CITY OF OREGON CITY HISTORIC REVIEW BOARD AGENDA

Staff Report

GLUA-26-00008/HR-26-00002: 204 Jefferson St. - Wall Height

REQUEST: Adding an 8 ft gabion wall to the rear of the Historically Designated Frank and Annie Busch House requiring Historic Review per HRB Policy #6.

Figure 2: Site Map with location of proposed wall

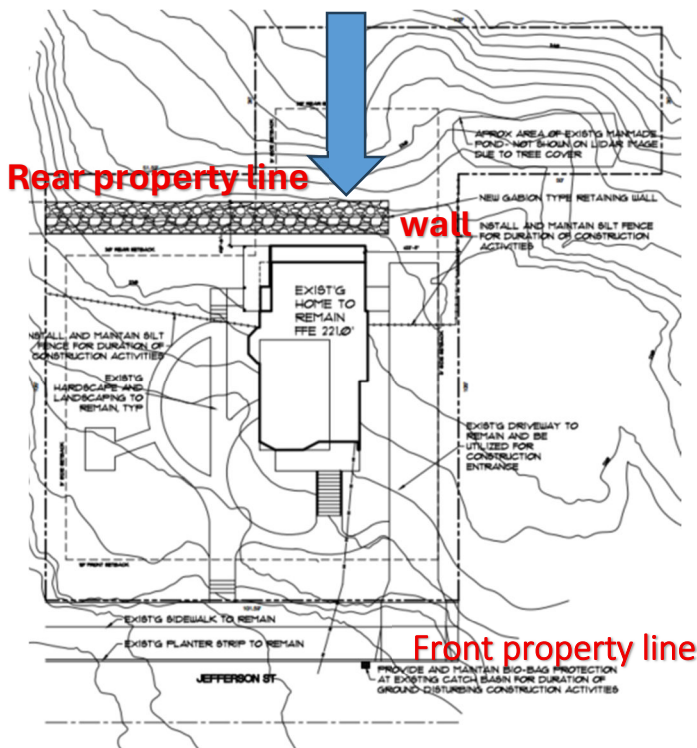
The only portion of this submittal that must be considered by the Historic Review Board is the deviation from HRB policy #6 to increase the wall height from the policy standard of 6 ft to a height of 8 ft. (See figure 2)

Finding: HRB direction requested. The applicant has chosen Gabion style retaining wall which meets HRB policy #6 for compatibility of design and material; however, HRB policy #6 states that along rear and interior side yards, fences or walls may be up to 6 ft in height. This wall has been proposed at 8 ft as designed by the geotechnical engineer for stabilization; therefore, HRB direction is needed for the retaining wall height as proposed over the 6 ft maximum per HRB policy #6. The Oregon City municipal code Chapter 17.54.100.A.3 allows for a retaining wall next to and behind the forward most building to be up to 8.5 ft in height from the finished grade.

Gabion RW Cross-Section

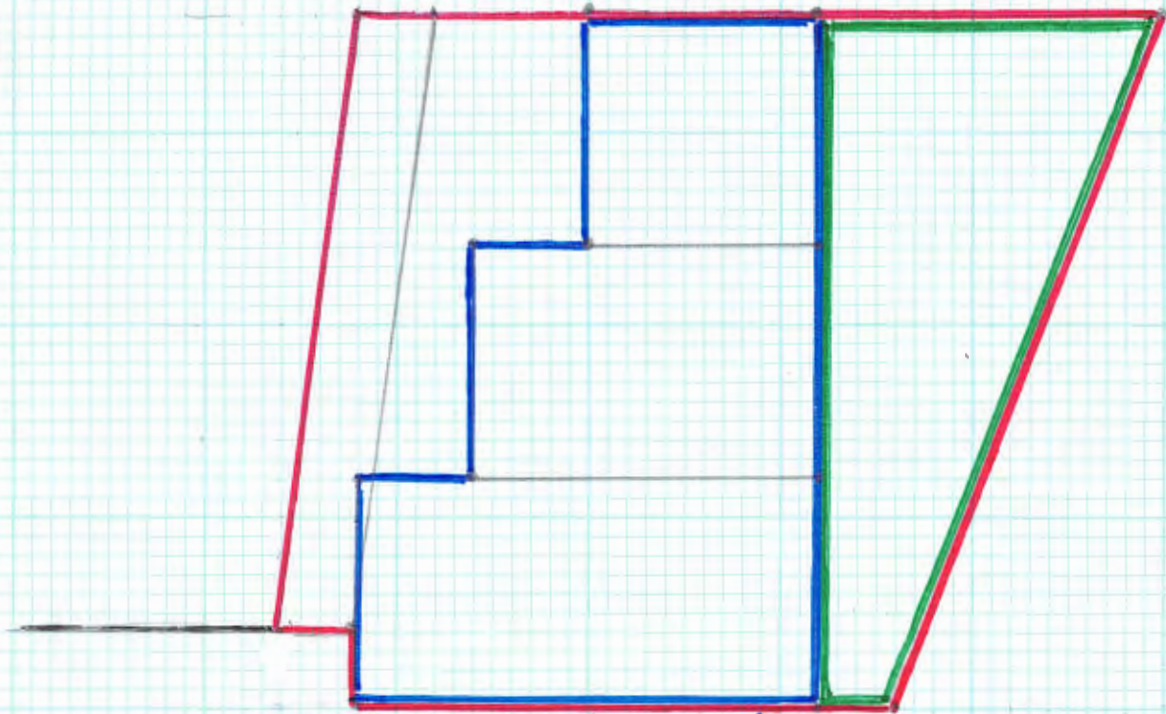
Item #5: Attached is a scaled drawing (Figure No. 3) which shows the cross-section of the proposed eighty-five (85) feet long gabion gravity retaining wall work area. The estimated volume of excavation to remove the existing rockery wall and excavate the existing easterly rear slope area at a slope gradient of 1/2H to 1V is approximately 7,075 cubic feet while the estimated volume to construct the new Gabion gravity retaining wall and rock spall wall backfill is 3,440 cubic feet and 1,910 cubic feet, respectively.

Figure 4: Sign Measurements with design options 1 and 2

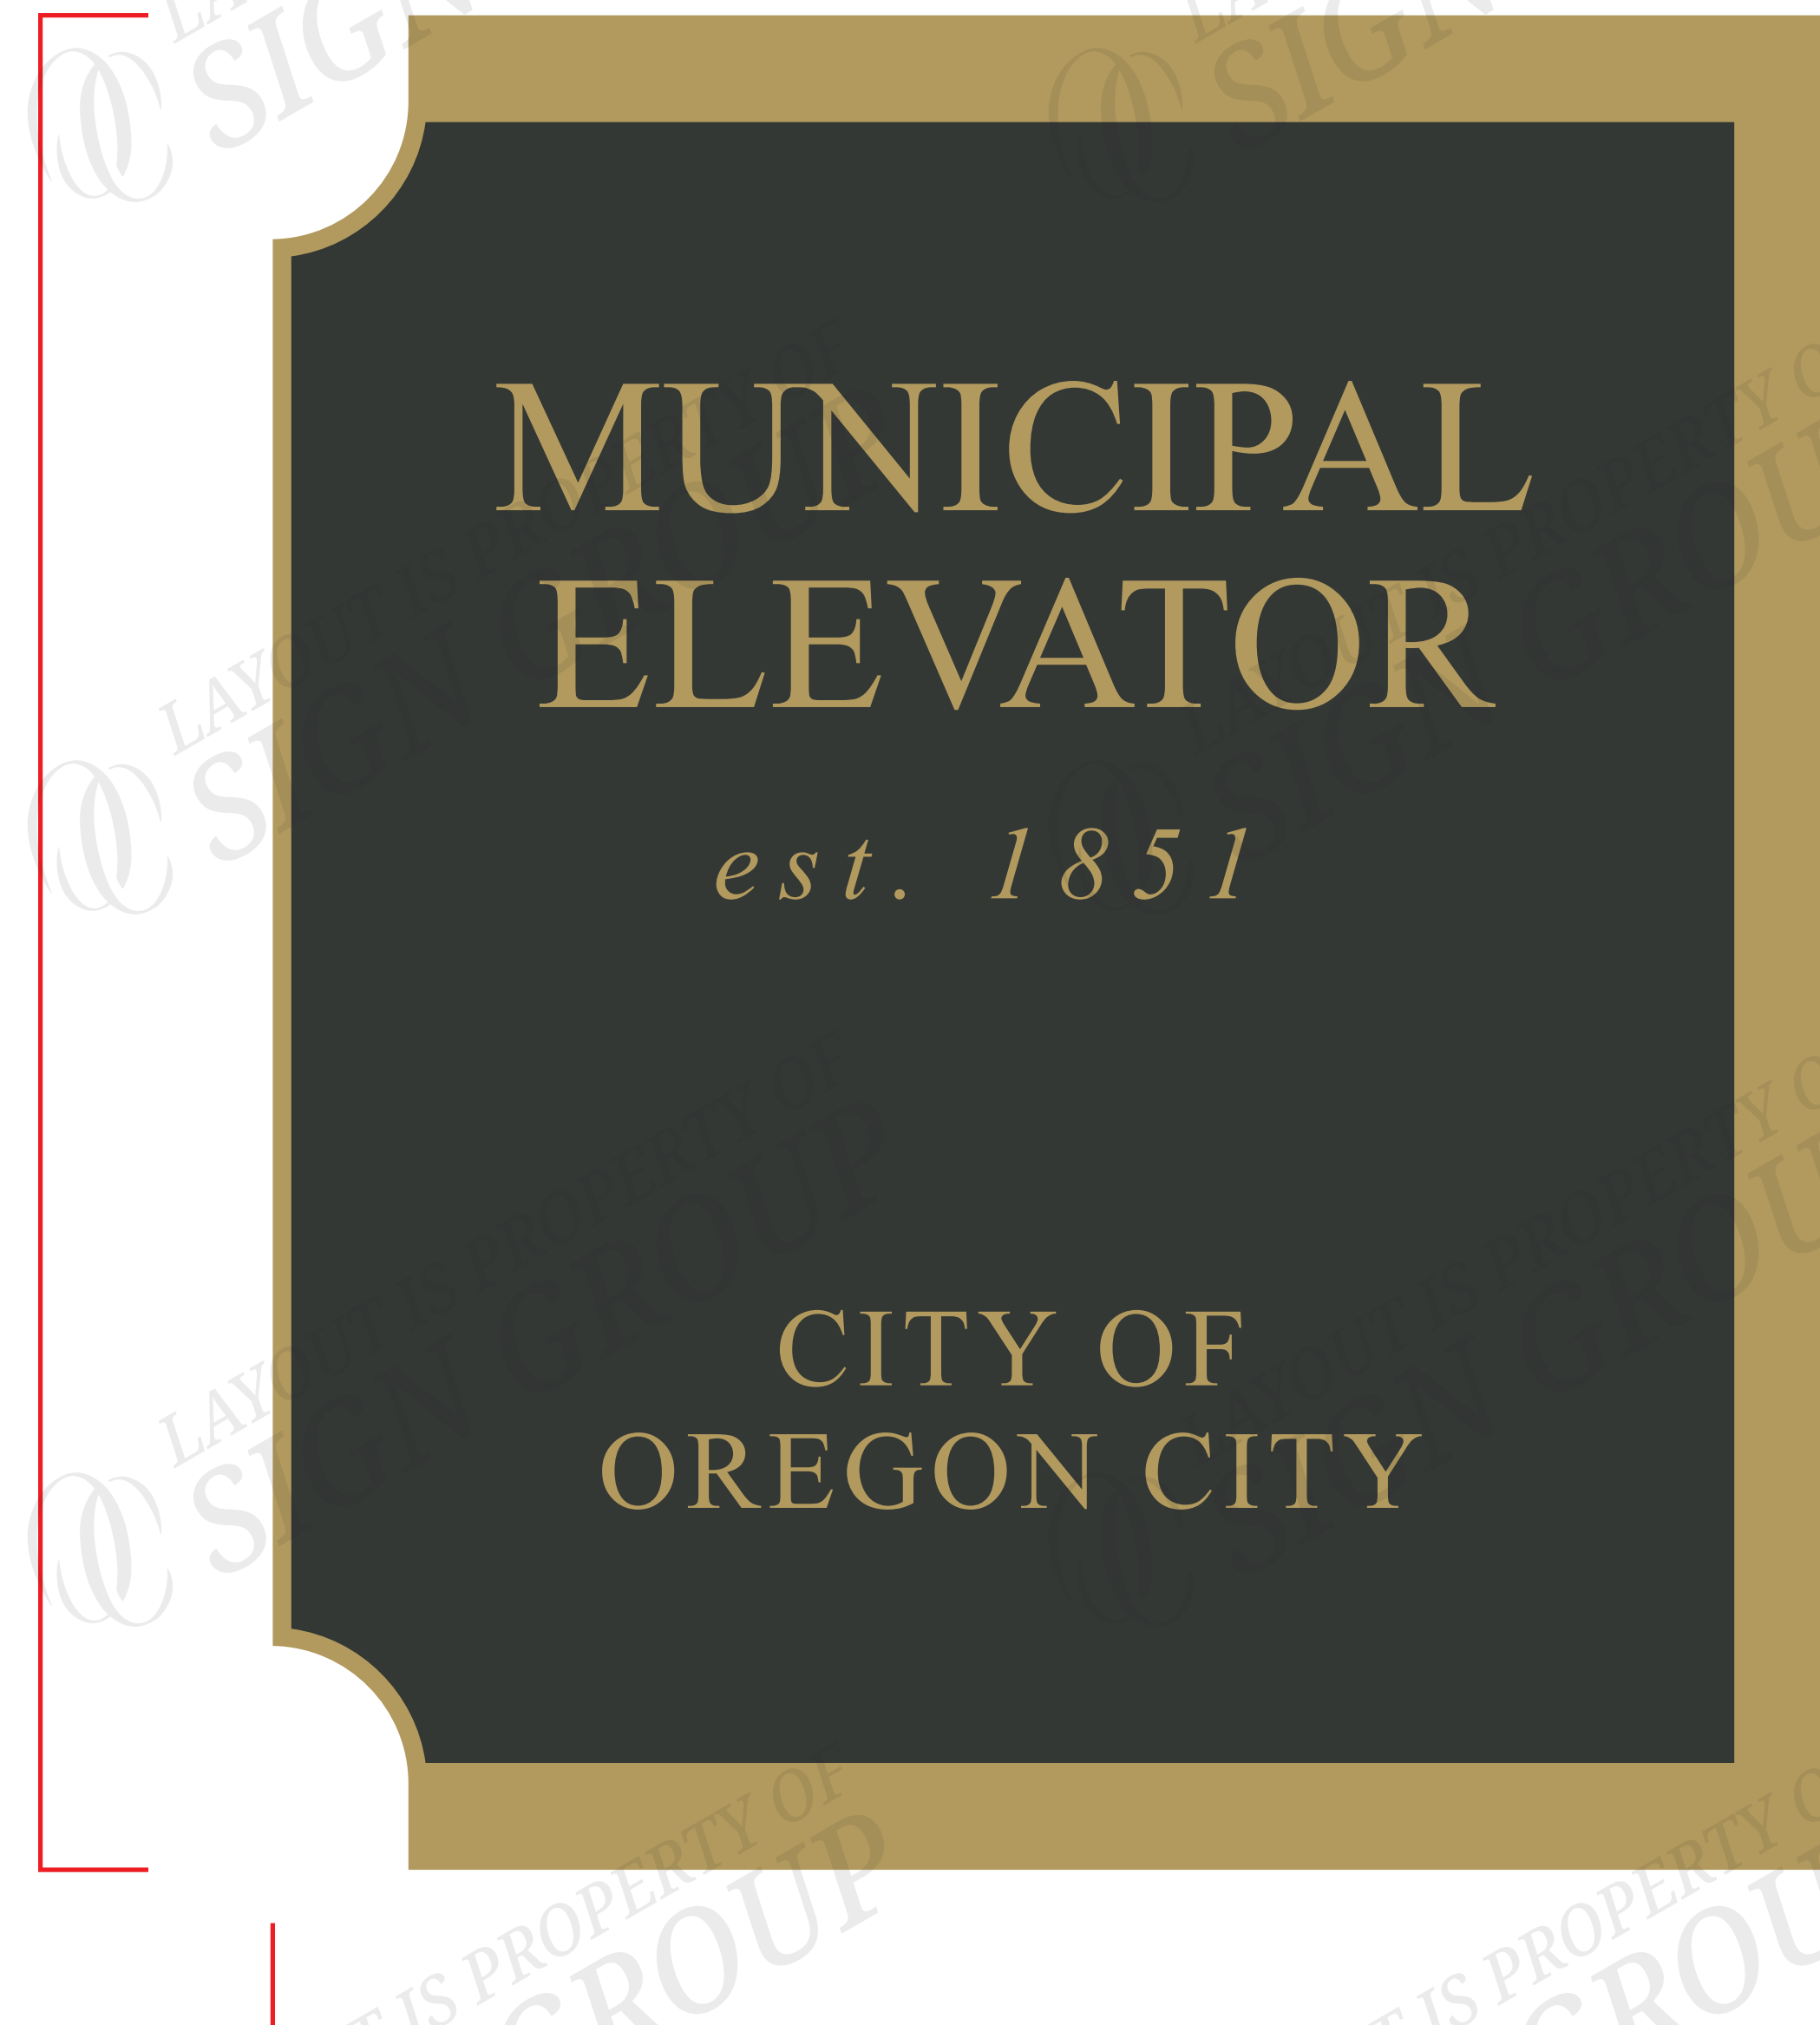
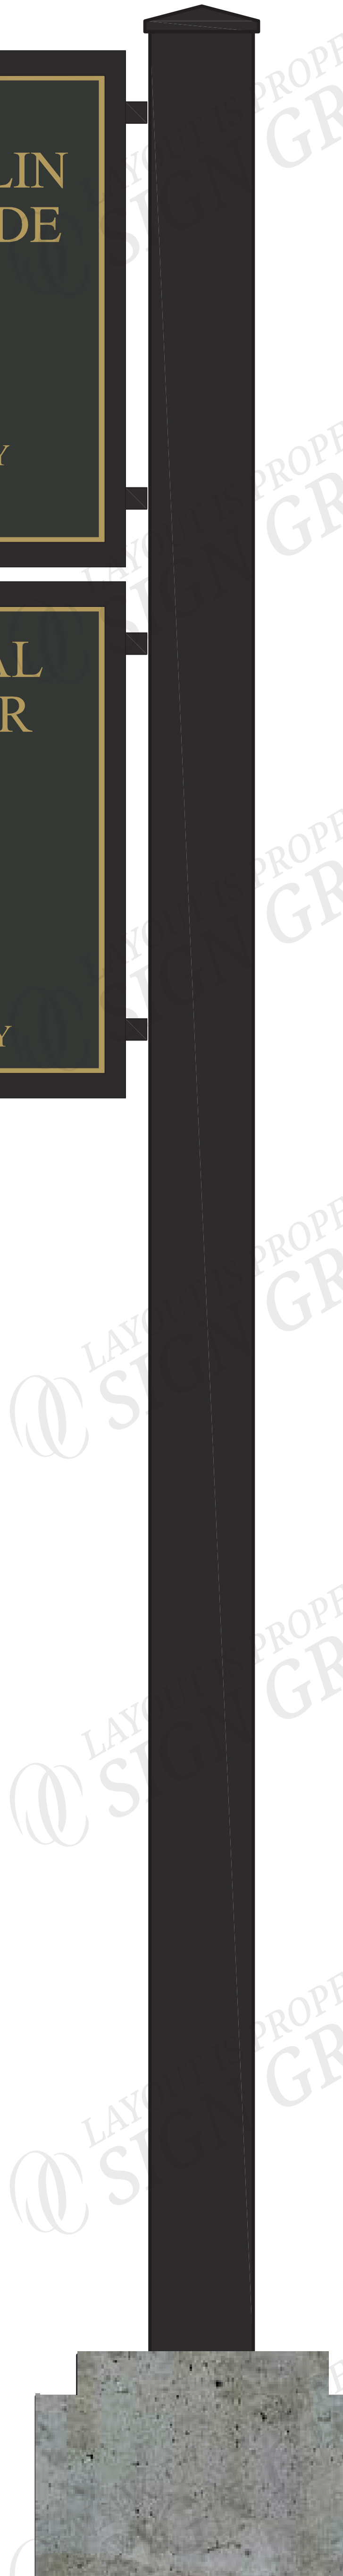
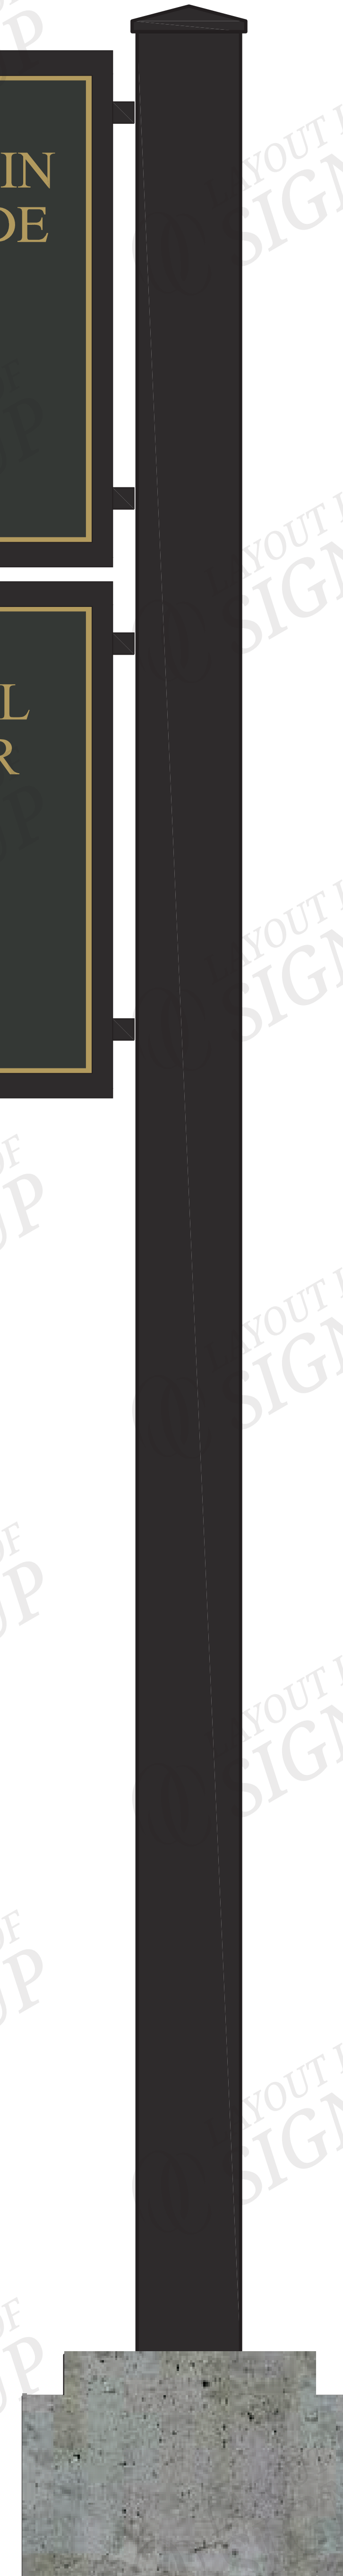
Finding: HRB direction requested. The proposed sign uses dark laminate material with a metal channel frame powder coated finish. The sign is outlined in gold, with gold lettering. While stone, metal and wood materials are preferred by the guidelines, the laminate plastic proposed is high quality and resembles powder coated metal. The signpost material is a black powder coated metal. The sign face and signpost match the existing signage placed between 2007-2012 at location 2 (see figure 3). This would remove existing blue and white signage and create signage uniformity and less sign clutter. **Staff is requesting HRB direction on the proposed laminate sign material compatibility.**
